## CONSERVATION TEAM CONSULTATION APPLICATION RESPONSE

| <b>APPLICATION REF:</b>      | 25/01767/FPH                                                                                                                                                                                        |
| <b>APPLICATION SITE:</b>     | Windmill House, Bennetts Lane, Rushden, Buntingford<br>Hertfordshire SG9 0SH                                                                                                                        |
| <b>DESCRIPTION OF WORKS:</b> | Erection of detached timber garage and workshop outbuilding with storage, following demolition of existing detached outbuilding/garage (as amended by plans received on 07/08/2025 and 16/09/2025). |

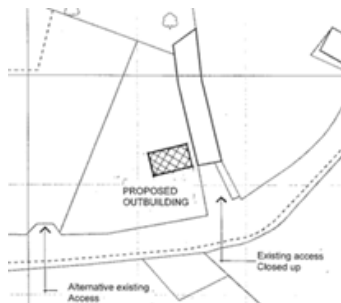
I have not been to site to inspect the interior of the building, and no survey is provided indicating whether it is structurally sound and 'fit for purpose'. It is acknowledged that the existing outbuilding is not conducive to providing 3 garage spaces. If the building serves as a workshop and log store and maybe parking for one vehicle, the question is whether the proposal can be justified as providing the additional footprint for a home office/gym considering this distance from the main house and at the entrance to the RCA. Can this be described as a 'home office' in planning terms in this location?

I have not been able to ascertain or attach any significance to the outbuilding in heritage terms, and I do not consider that it contributes to the significance of Windmill House or indeed any other listed buildings in the vicinity. The building is discretely located off Bennett's Lane behind a road frontage tree/scrub screen. In my opinion, the outbuilding's appearance as a low, linear outbuilding is such that it has a relatively neutral impact on the character and appearance of the RCA. I note two garage/outbuildings in a more conspicuous location south of Old Thatches

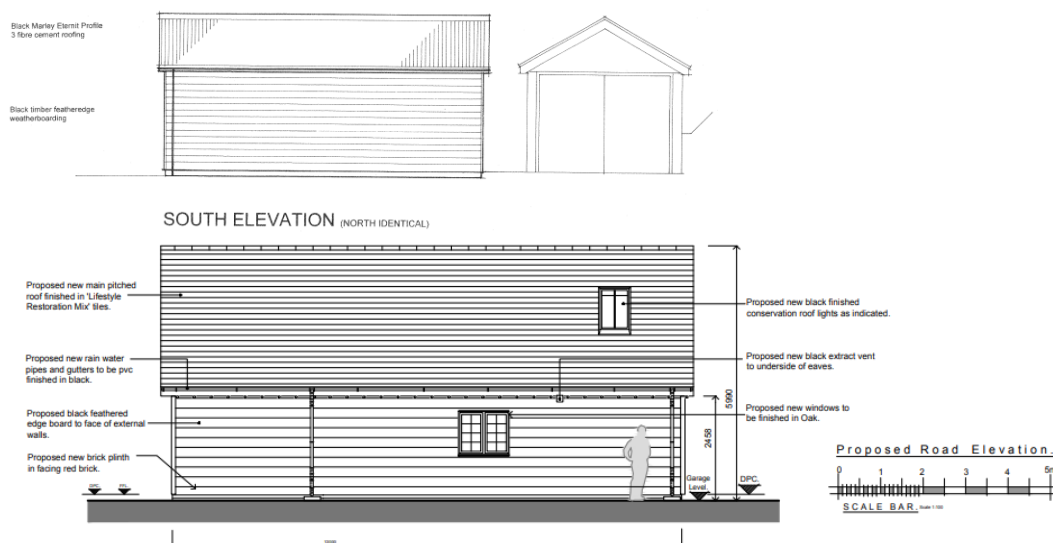
The current proposal would result in a similar 'L-shaped arrangement' to that of the existing building + the scheme approved under ref: 13/00053/1HH (had that been implemented). Whilst similar in form, the current proposal is nonetheless wider and taller. Although I appreciate the similarities here, the erection of a 20,230mm long building with a 5990mm ridge and 6000mm gable widths will result in a substantial building when compared with the existing. Furthermore, the cumulative impact of the framed and glazed west facing gable end, the glazed doors to the north elevation, small-pane windows, and several roof lights, would result in an outbuilding with an overly residential character. There is an anomaly on the elevation in that there would appear to be north and south facing roof lights on the short projection when looking at the Front Entrance Elevation but there is no roof light on the north roof slope of the Proposed Gable & Entrance Elevation. There will be a minimum of 7 but maybe 8 roof lights proposed in total. It is unclear as to why 6no. roof lights are required over car and tractor spaces.

The existing building is much lower with no opportunity to create a first floor and the same can be said of the 2013 consented scheme. The new build is a much more substantial building and whilst a partial mezzanine is shown, a first floor could effectively be created throughout if permission is granted and I question whether this is why 3no. roof lights are shown on the east and west elevations?

- 2 tractor spaces (could reduce length by 1 bay?),
- 8no. roof lights (justification for 3no. east facing roof lights?),
- 2no. external entrances (access workshop through gym/office space?)
- Amount of glazing to the north and west elevation of gym/office (weatherboard gable end?)
